2016/0621/P

179 Camden High Street

Delegated Report (Members Briefing)		Analysis sheet	Expiry Date:	31/03/2016
		N/A / attached	Consultation Expiry Date:	31/03/2016
Officer			Application Number(s)	
Matthias Gentet			2016/0621/P	
Application Address			Drawing Numbers	
179 Camden High Street London NW1 7JY			2 x Photos; Email Response from Agent - 08/04/2016; Email Response from Agent - 05/04/2016; Agent's Response to CAAC's Objections - 24/03/2016; QF8554 PF5620 RP1 MGR - Noise Report ; PU.1015.30 - Design and Access Statement; [PU.1015.] 10 - Site Location Plan, 11 - Block Plan; [PU.1015.] 01 RevB, 05 RevA, 07 Rev C, 11.	
PO 3/4	Area Team Signature	C&UD	Authorised Officer Signature	
Proposal(s)				
The installation of 2no air conditioning condenser units at ground floor level, cold room condenser unit and an A/C condensing unit to rear first floor roof terrace, addition of 2no louvres panels, and replacement of existing rear sash window with louvre at first floor level, all to rear of retail unit (Class A1).

View showing the unauthorised A/C unit to be relocated, the small window to be obscured by it, and the white coloured louvre, and the pitch roof.

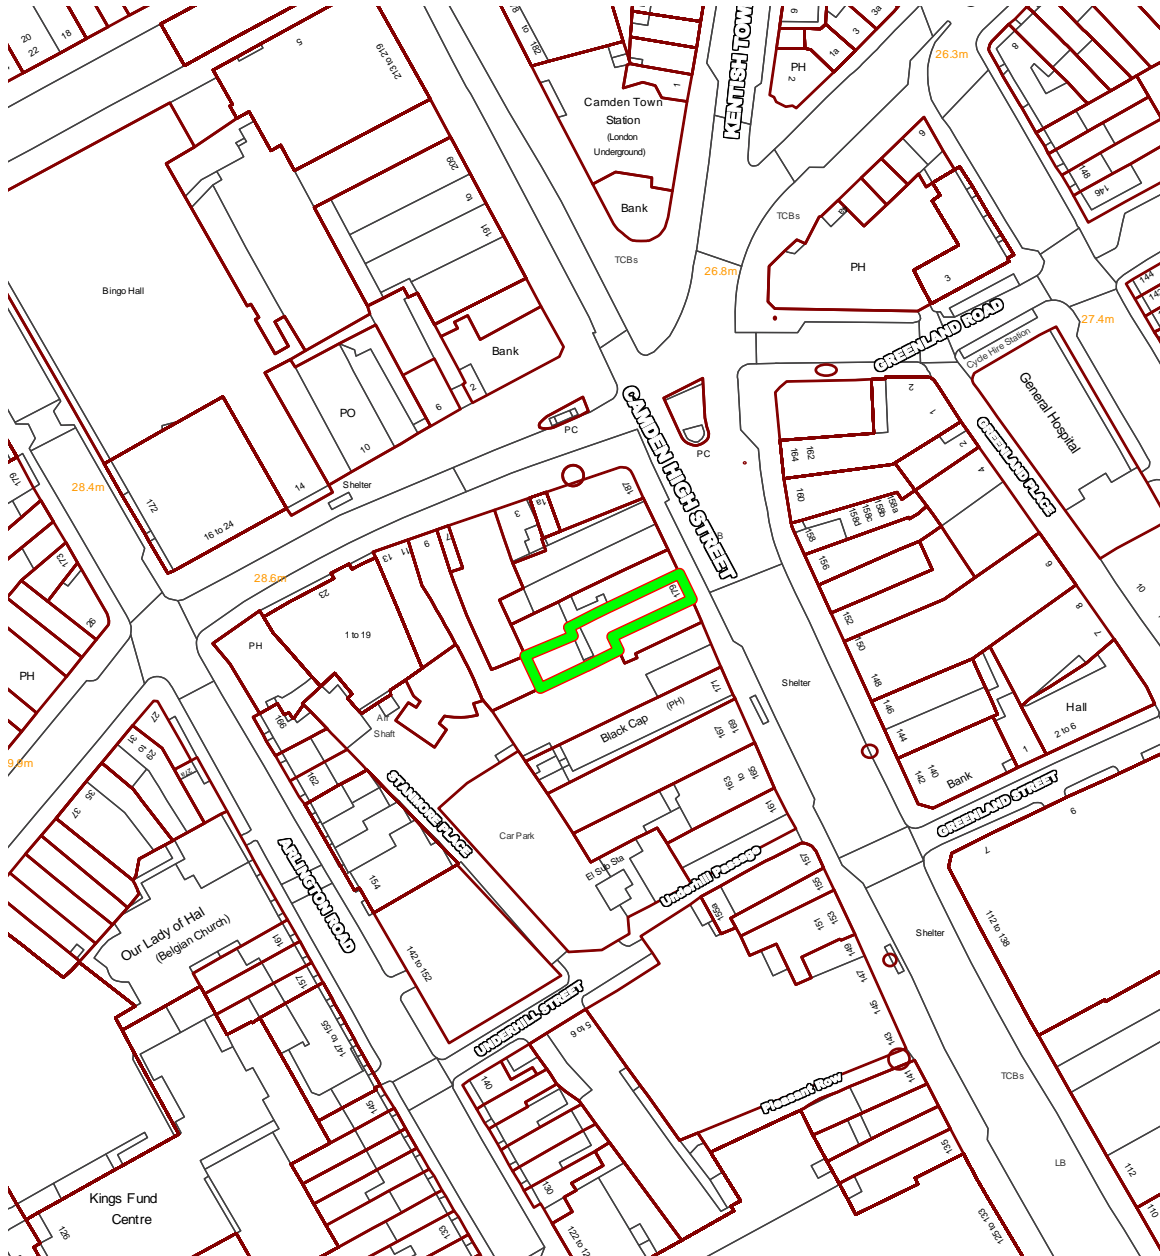
2.7 The fourth A/C unit has been installed on the side wall of the staircase extension, in line with the front edge of the

single storey rear extension. This prominent location was considered highly unsuitable, and an enforcement case reference: EN16/0316 (please refer to Relevant History) was opened as a result. It was therefore requested the unit be relocated towards to rear of the roof of the ground floor extension, behind the pitch roof, so that it is ceased to be an incongruous fixture and be less conspicuous. The proposal was amended accordingly to reflect this.

- 2.8 The new position is not an optimum location as it obscures a small side window being sited in front of it. However the window, which forms part of the rear ground to second floor extension housing a staircase, is not a historical feature of the building. Some of the original opening features were blocked up to accommodate the erection of the staircase. The existing window will not be damaged nor removed. A condition is to be added to have the unauthorised A/C unit painted black to reduce an element of light reflecting on it, and further reduce its visibility.

- 2.9 The existing sash window at first floor level is to be replaced with a louvre. Following a preliminary assessment, this element of the proposal received a negative response. Its refusal was considered to be a possibility. An opening under the existing sash window was put forward as a potential option which would allow for the retention of the sash window in its current setting. However, this was explained by the agent not be feasible in view of the extent of the internally installed equipment which required a ventilation outlet large enough to be efficient.

- 2.10 Following reassurance and confirmation by the agent that the sash window is to be retained on site, its replacement was considered to be acceptable. This is therefore to be conditioned as such and subsequently reinstated when the current occupier is to vacate the premises. The original white colour of the louvre has been viewed to be inappropriate as this would create a shining surface and would be detrimental to the character of the conservation area. It was therefore requested that the proposed louvre be painted in black to be, similarly to the condenser unit, less conspicuous

- 3.1 Grant Conditional Planning Permission with Warning of Enforcement Action to be taken to have the unauthorised A/C unit relocated from the edge of the roof of the single storey extension to the rear, behind the pitch roof and to the side of the staircase extension.

- 5 The louvre hereby approved shall be painted black. The original sash window is also to be kept on site and shall be re-instated prior to vacating the premises when such time arises.

- 6 The plant units hereby approved, shall be painted black.
